**M25 junction 10/A3 Wisley Interchange
TR010030**

**9.100 Applicant's Response to RHS's
Deadline 7 Submission**

Project:	M25 junction 10/A3 Wisley Interchange		
Subject:	RHS Wisley tree impacts		
Author:	Thomas Dale		
Date:	14/01/2020	Project No.:	5190926

Image 1.0: Crib wall retaining structure, requiring the excavation of the verge beyond the extents of the structure to enable the inclusion of a crushed gravel backfill.

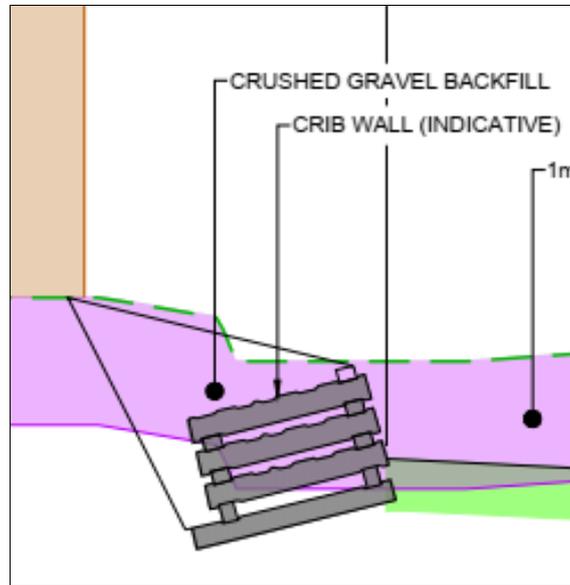
- 3.1.12 This technical note is appended to this response and covers an assessment of the impacts from the works as originally proposed in this location, namely a retaining wall structure and extensive works in the A3 verge as part of the A3 widening in this location. The technical note also addresses **point 4** of Mr Barrell's letter regarding the explanation of the phrase 'structural root zone'.

- 3.1.14 Highways England agrees with Mr Barrell regarding the root protection area (RPA) capping at 15m according to BS5837. Highways England's arboriculturists did not apply at cap of 15m because RPAs can be modified in line with the BS5837:2012 guidance to take into account conditions not conducive for tree root growth, such as (in this case) the A3 and existing hard infrastructure. The realignment proposed in this location minimises/removes construction within the verge and any impacts on the RPAs of the trees.

The proposals along this location require modifications in order to retain the trees. The preference would be to retain the existing verge as it currently is and move the works into the carriageway by utilising the central reserve.
